APPLICATION NO.	FILING DATE	FIRST NAMED INVENTOR	ATTORNEY DOCKET NO.	CONFIRMATION NO.
10/719,352	11/21/2003	John R. Wall	3257-031853	3304

Office Action Summary

DETAILED ACTION

Figure 1

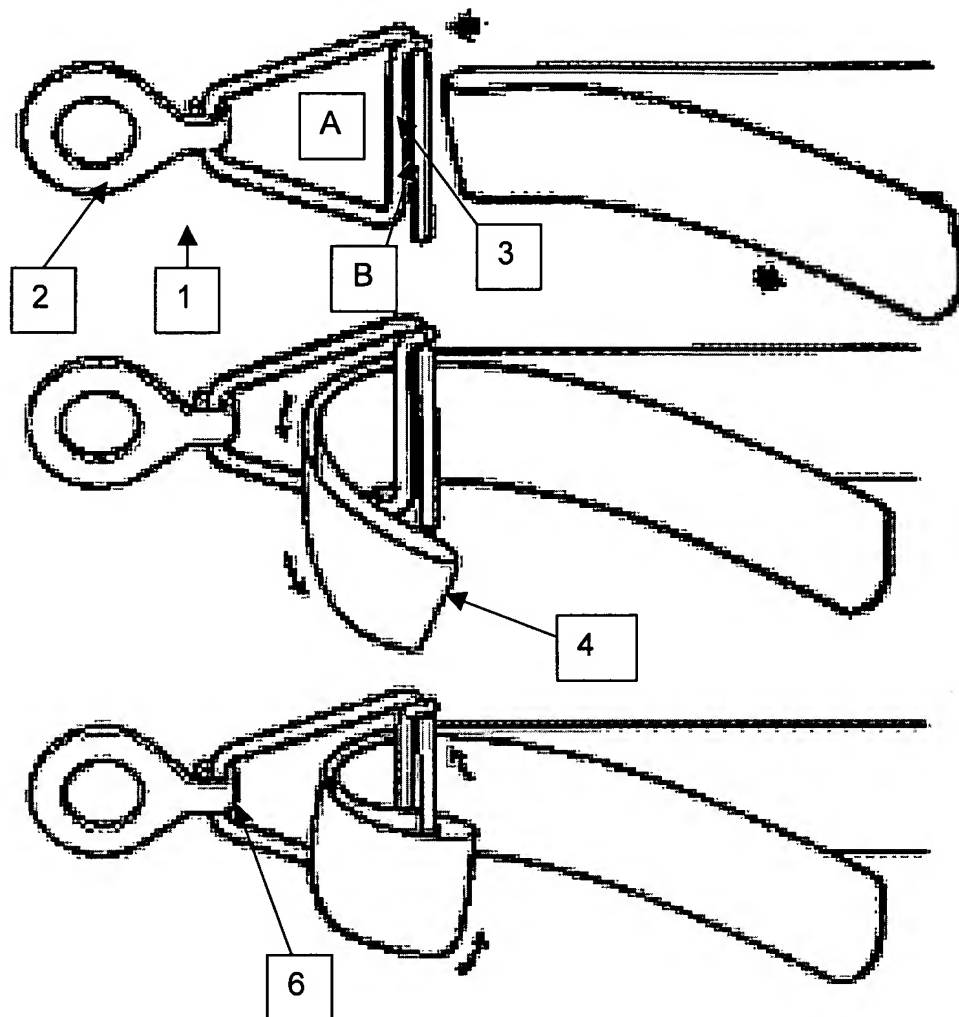
As to claim 1, Safe-Fence discloses a fence comprising a rail consisting of at least two metal wires ensheathed in a plastic web (the webbing used for the fence is disclosed as having stainless steel wires interwoven), a slotted connector (1) having a face plate (encompasses the entirety of 1) with two slots (A and B) and a middle portion (3) separating the two slots, the connector having a front side (facing away from reader) and a rear side (facing toward reader) and also having a post attachment end (2), a free end of the rail (4) being disposed in the slotted connector so that the rail runs from the front side of the connector through a first slot (A) nearest the post attachment end, round the middle portion (3), and then back through the second slot (B), and a post (5) to which the slotted connector is attached using a fastener (5).

As to claim 2, Safe-Fence in view of Johnson discloses a fence wherein the end connector comprises return edges extending along opposing sides of the rigid member, the return edges extending perpendicularly from the faceplate (the hooks 6 shown on either side of component 2 on the R-50 corner tensioner, curve perpendicularly away from the plane of the faceplate).

As to claim 3, Safe-Fence in view of Johnson discloses a fence wherein the end connector is attached to the post using a fastener (see figure 1) which permits the connector to pivot about the fastener.

As to claim 4, Safe-Fence in view of Johnson discloses a fence wherein the faceplate further comprises a through hole (see 2) adapted to receive the fastener.

As to claim 6, Safe-Fence in view of Johnson discloses a fence wherein the faceplate (encompasses the entirety of 1 includes a bend between the first slot and the post attachment end (2) (this is shown in figure 1 in the photo of the R-50 corner tensioner).
